SERVICE BULLETIN

M1535 2022-03-14

M1535: SERVICE MANUAL AND ISHEET HANDLEBAR INSTALLATION REQUIREMENTS UPDATE: MODULAR BRAKE LINE KITS

Figure 1. Single Disc Brake Line Orientation

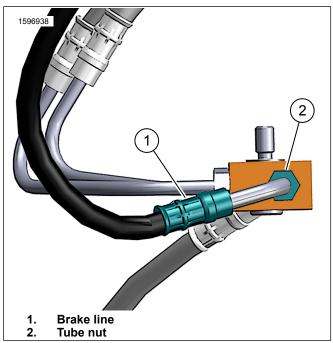
Some front brake lines have been found damaged, which we believe resulted from servicing the brake line from the master cylinder to the manifold. The service manual has been updated to show the correct orientation of that brake line in relation to the manifold to prevent contact with the lower triple clamp when handlebars are turned to full right lock. A note was also added to the SM to inspect that the manifold is free to rotate but should remain primarily stationary when rotating handlebars from full left to full right. The orientation of the brake line and behavior of the manifold should be similar if installing P&A front brake lines on any 2018 and later Softail.

- See Figure 1.See Figure 2. Position brake line (1) in orientation shown and snug tube nut (2).
- Move handlebars to full left lock and full right lock, adjust brake line as needed.
- Tighten tube nut. Torque: 14.5–19.5 N·m (128–173 in-lbs)
 Brake line tube nuts, manifold.

Move handlebars to full left lock and full right lock to verify brake line routing and there is no binding of brake lines or manifold.

Manifold assembly should face forward, primarily stationary but free to rotate.
